AGENDA  
COMMITTEE OF THE WHOLE  
May 23, 2017  
2200 Harnish Drive  
Village Board Room  
- AGENDA -  
7:30 P.M.

SUBJECT: *Glenloch PUD Amendment and Final Plat of Resubdivision Request*

DATE: *Wednesday, April 26, 2017*  
TO: *Russ Farnum (VoA)*  
FROM: *Shawn M. Hurtig*  
SUBJECT: *Public Works Review # 1 – 60% Submittal*  
*Glenloch Re-subdivision (CD2017-04)*

Subject: Glenloch Residential Subdivision – FIRST REVIEW  
Algonquin Case No. 2017-TBD  
(CBBEL Project No. 070272.0005A)

**ANDARE FLEX LOTS**  
GLENLOCH OF ALGONQUIN  
ALGONQUIN, ILLINOIS

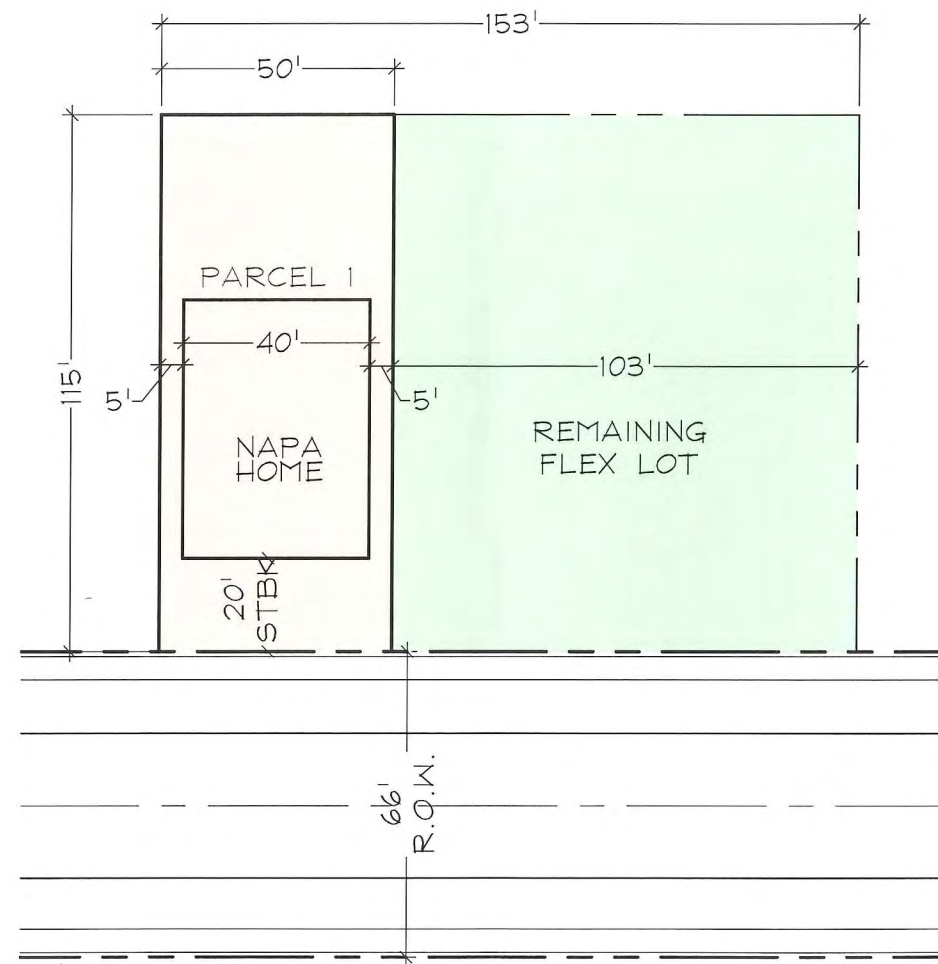
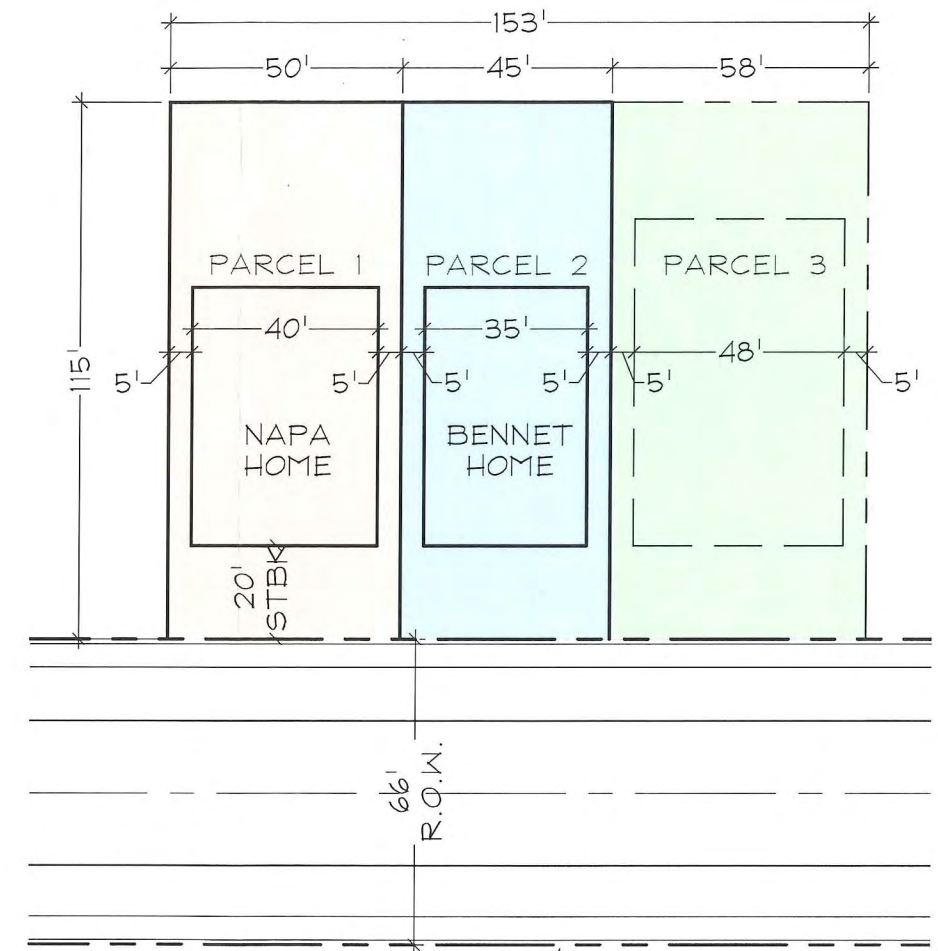
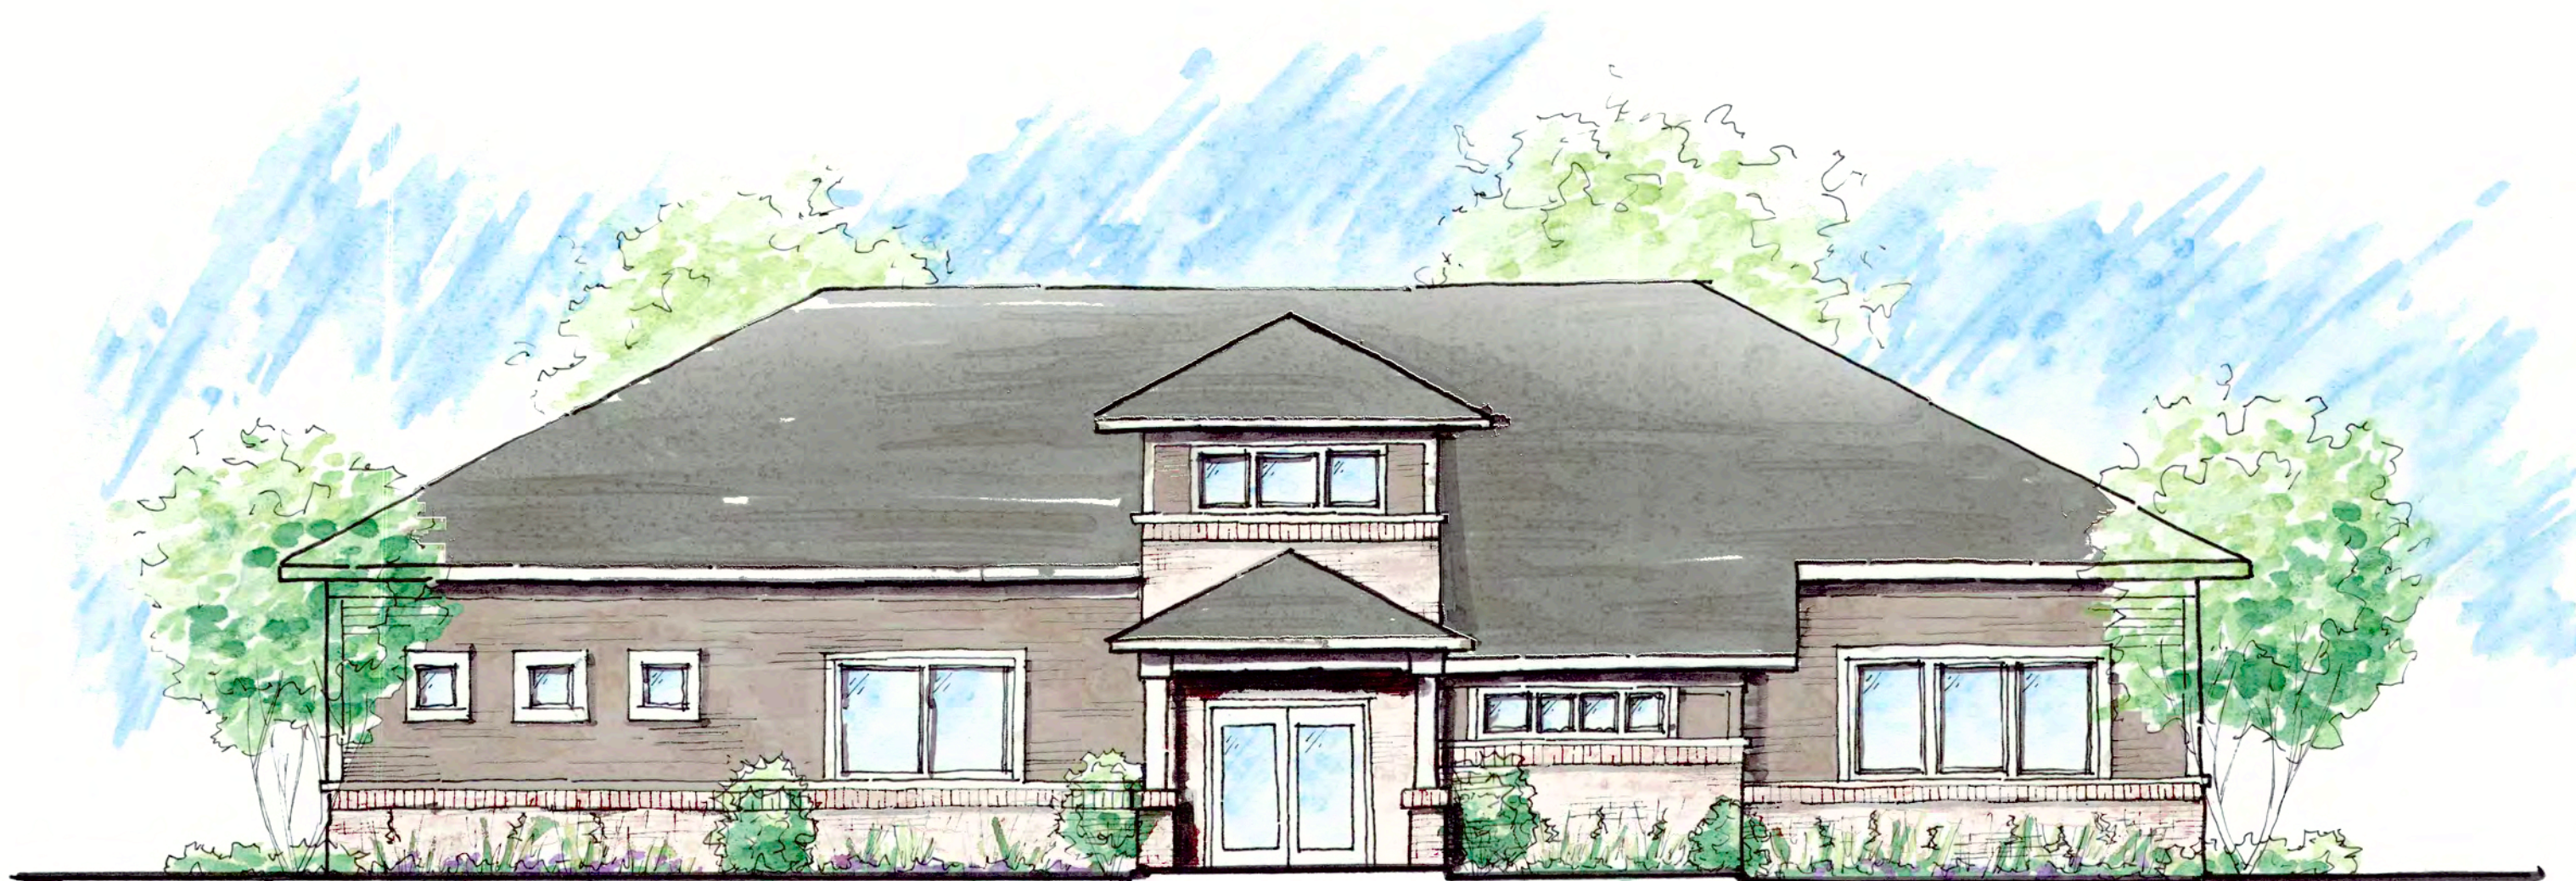
A unique approach is the proposed “Flex Lots”. The concept is that the building pad planned for a 4-unit townhome would be resubdivided to provide for 3 single family homes, with the lot lines drawn after the units are sold. The developer is requesting flex lots because they offer a variety of models, with widths ranging from 35 feet to 50 feet, and the lot lines would vary depending upon the model sold with each building pad.

While Staff is willing to allow flexibility, this approach is problematic for a number of standpoints, the least of which is tracking an ongoing series of resubdivision plats and changing property index numbers. It also creates potential problems with sequential lot numbering, assuring that the resubdivision plats get recorded, and the issue of processing reviews and approvals of those plats. By Village code, each of those resubdivisions would have to come through the Planning and Zoning Commission and Village Board for approval, which is time consuming and could rapidly become tedious.

An elegant solution is to plat all three lots on the individual flex lots at once. Each building lot already has a proposed building pad that outlines the maximum house envelope, as shown on the final engineering plan. By simply platting the three pads per outlot with the first unit, the developer would know which models fit each lot, which is limited by the engineering, and would not need to follow through with a series of resubdivisions. Staff supports this approach and recommends the Committee and Board approve administrative review and processing of these resubdivision plats, as outlined in the recommended conditions of approval.

**AMENDED P.U.D. SITE PLAN**

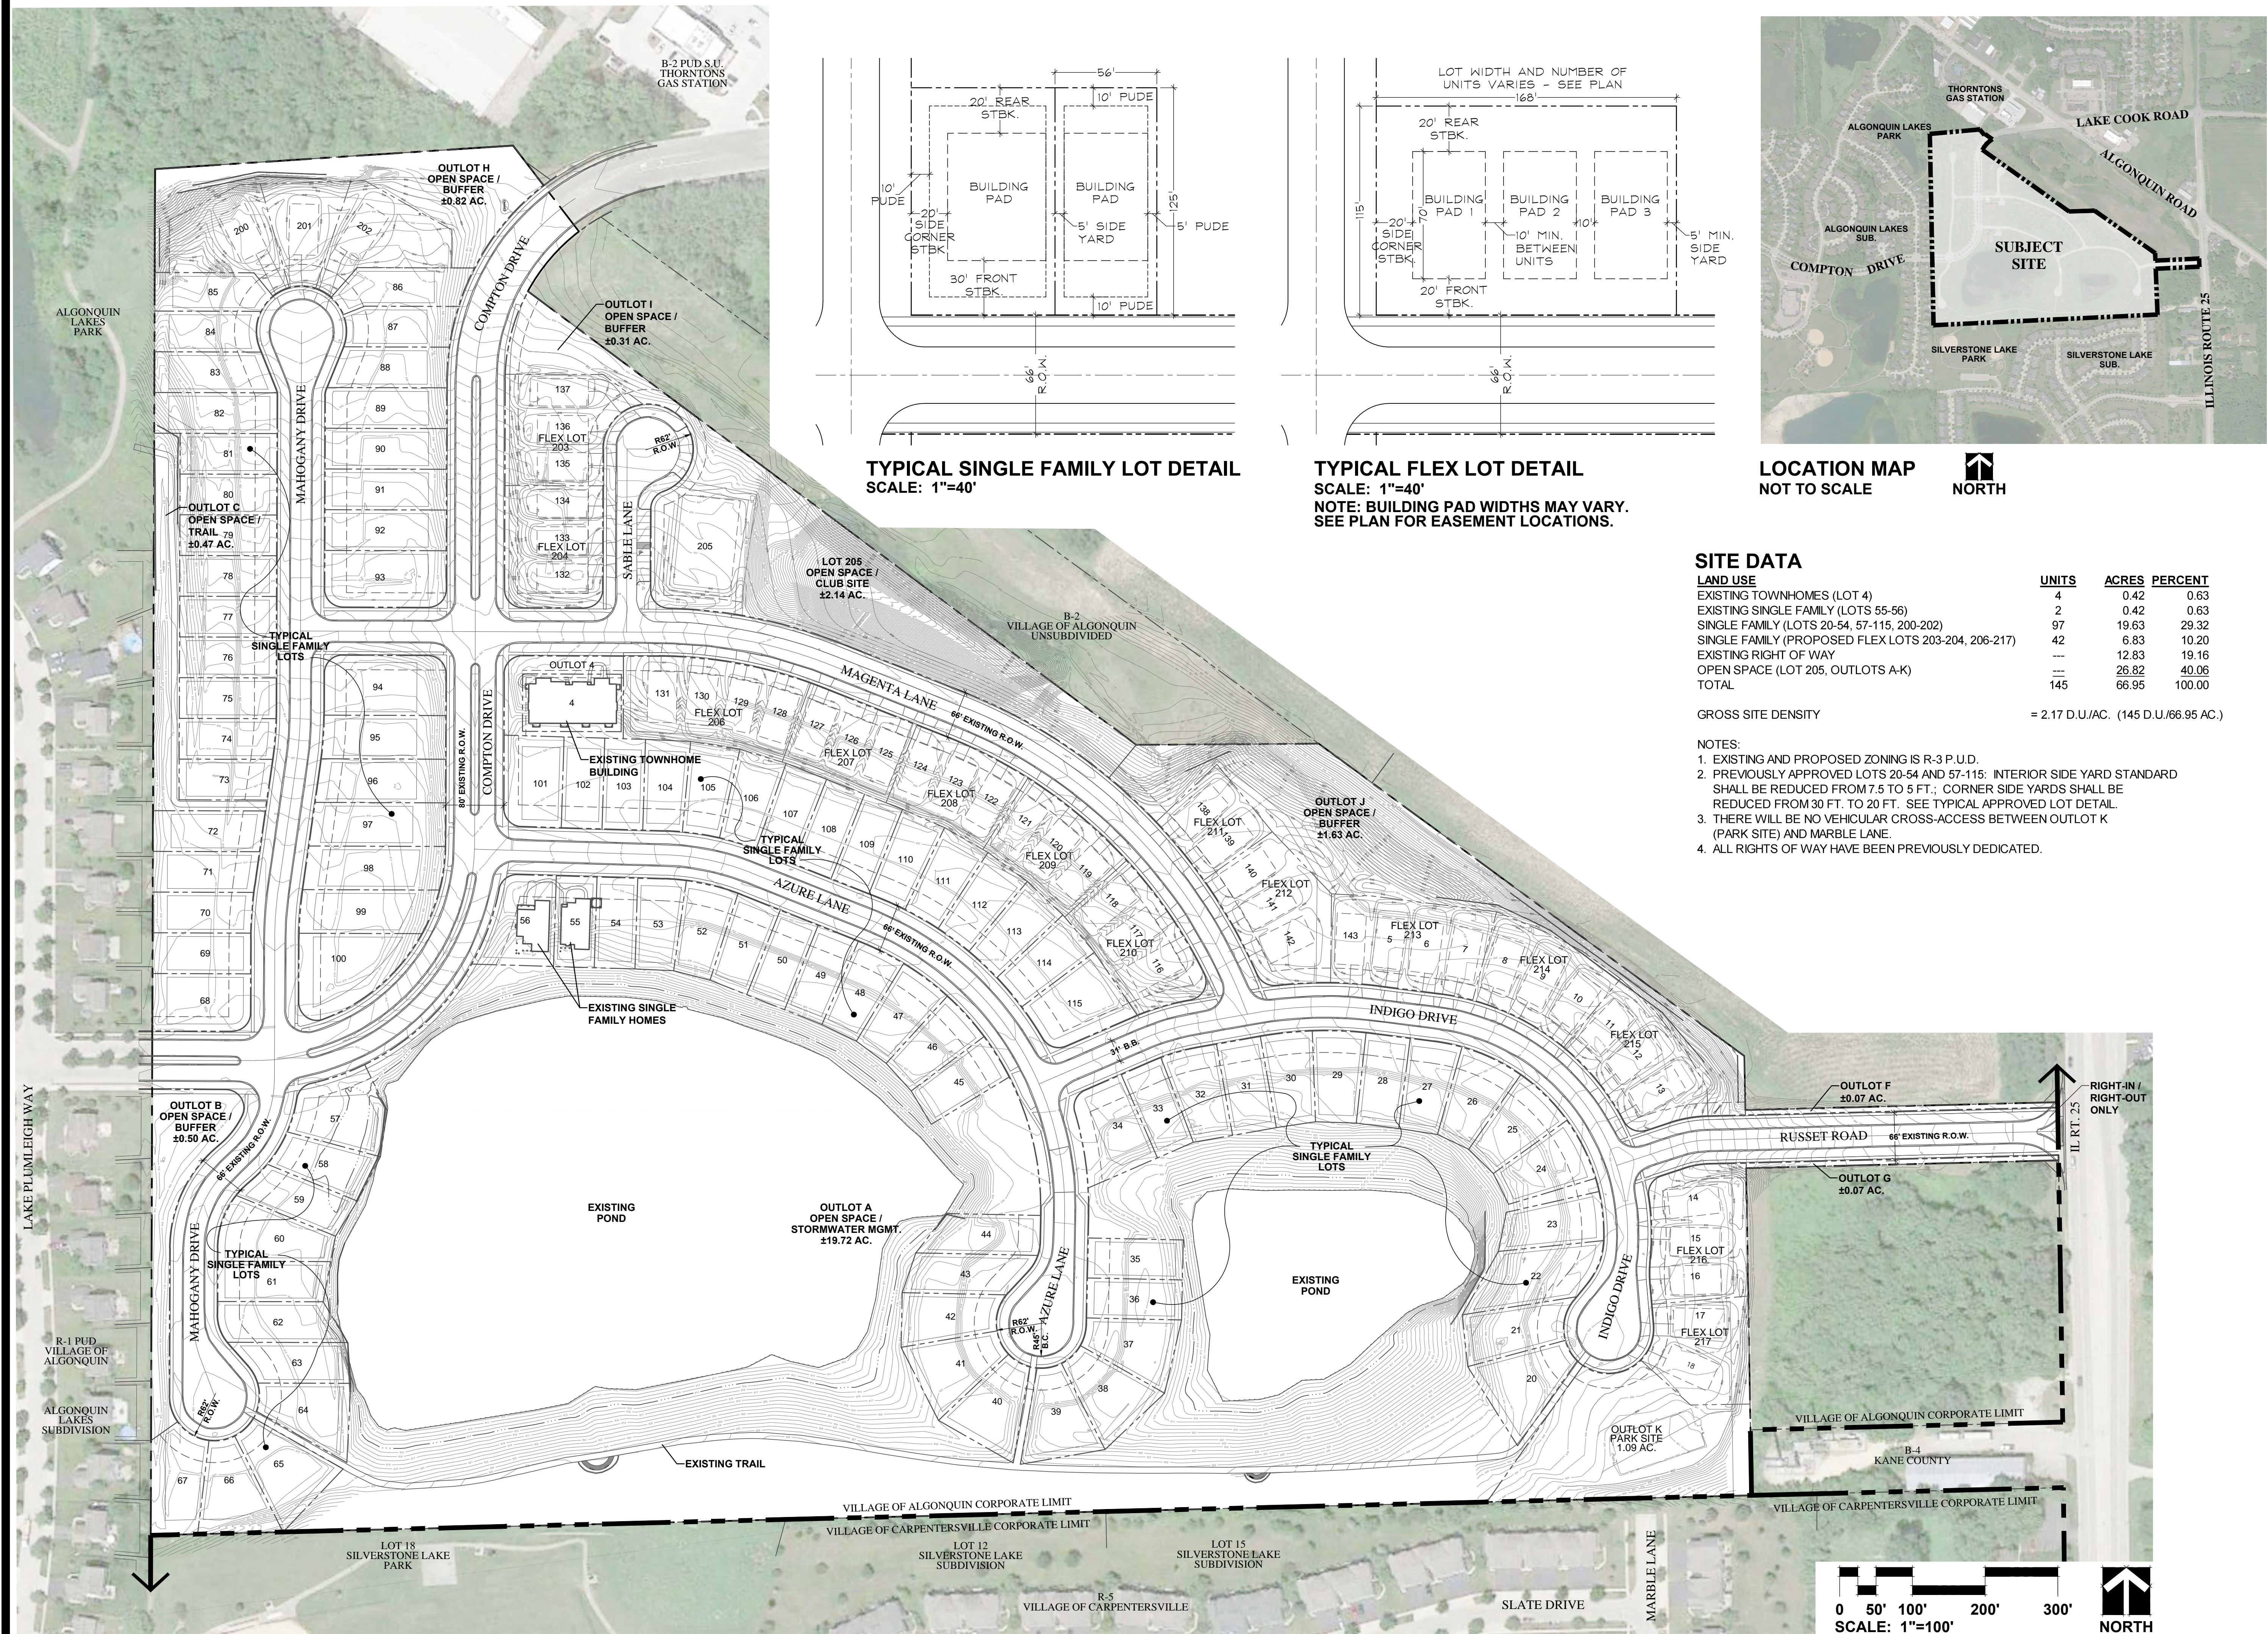
The developer is showing on-street perpendicular parking for the clubhouse. This is not allowed by Village code, and discouraged by Public Works. The developer has only provided a draft building elevation and layout concept, with no details on the building materials nor the amenity nor landscaping package that will accompany the new community center. The original clubhouse plan included a pool and substantial park-like amenities. Staff recommends that those details be submitted for Staff review and recommendations.

The front yard setbacks for this subdivision are platted at thirty feet (30') even for the townhomes. The new lots are showing a variety of front yard setbacks starting at as little as twenty feet (20'). The Village standard has been thirty feet and staff does not recommend varying from that requirement.

4. The front yard setback of 20' noted in the TYPICAL LOT EXHIBIT is not consistent with the information provided on the Amended P.U.D. Site Plan. The engineer shall coordinate the documents and revise them as required.
